SUMMARY

Applicant	Property Location: 44 E Vanderbilt St.	Staff Recommendation: Approval of the
Andrew Kaufman Rare Builders	(southwest intersection of E. Vanderbilt St. & Formosa Ave., north of E New Hampshire St.)	replat, subject to conditions in this staff report.
Owner	(Parcel #14-22-29-9240-02-020; 0.3 acres, District 3).	
Nilesh Bhavsar	District 3).	
Project Planner		
Jacques Coulon	Applicant's Request: Minor Subdivision request to plat the property into two lots for single-family development. Currently there is a single family home that straddles the proposed lot line which will be demolished.	
Updated: November 25, 2015

Based on the information provided in the staff report and the findings noted above, staff recommends approval of the Vanderbilt Formosa Subdivision Replat, subject to the conditions in this staff report.

PROPOSED PLAT

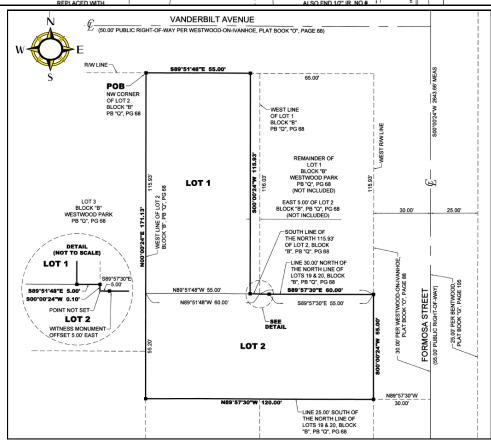
1. Please have the suveyor provide a one-and-the-same letter certifying the legal description shown on the plat describes the same area as the legal description shown on the title opinion.

Plat Face Changes - There are a number of changes required to the face of the plat. In addition to the changes required on the plat, the following is a list of additional requirements.

- 1. Changes to the face of the plat. (A copy has already been returned to the surveyor).
- 2. Recording Fees (Checks should be made payable Orange County Comptroller.)
- 3. The plat must be reviewed by Orange County prior to recording. Begin this process by taking a copy of the executed plat to Room 1700 (Orange County Property Appraiser's Office, Attn. Rocco Campanale), 200 S. Orange Avenue, Sun Trust Bank Center. The original completed Statement of Lien from Orange County is required by this office. The Statement of Lien must be received by this office prior to recording the plat.

- 1. <u>SEWER-MISC.</u> A gravity sewer connection may not be available to serve the newly created parcel fronting on Formosa Ave. Please contact the Wastewater Division to discuss sanitary sewer availability.
- 2. <u>Sidewalk</u> As per Section 61.225 of the Land Development Code, a 5 foot wide concrete sidewalk is required along all dedicated rights-of-way. Any existing sidewalk damaged or broken is to be repaired.
- 3. <u>Engineering Standards Manual</u> The City Council Adopted the Engineering Standards Manual (ESM), Fourth Edition, on March 9, 2009. All plans must conform to the ESM and all construction must be accomplished in accordance to the ESM.
- 4. Sewer-Benefit Fee The Office of Permitting Services has reviewed final plans for this project. The owner/developer is required to pay the Sewer Benefit Fee in accordance with the Sewer Service Policy.
